RIOCAN – WINDFIELDS FARM BLOCK B2 SOUTH, BUILDING B5: RFP – ADDENDUM N0.01

ADDENDUM NO.1 ISSUED: July 12, 2023

Windfields Block B2 South, Building B5
Construction Tender
RFI #1

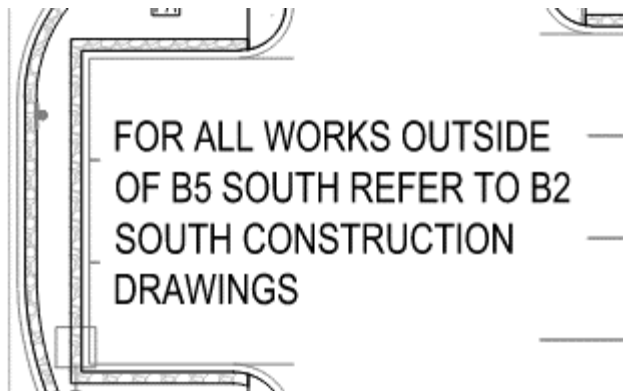
Could you please clarify what document is the below snippet referring to? The civil set of drawings has a different boundary than the Landscape and architectural.
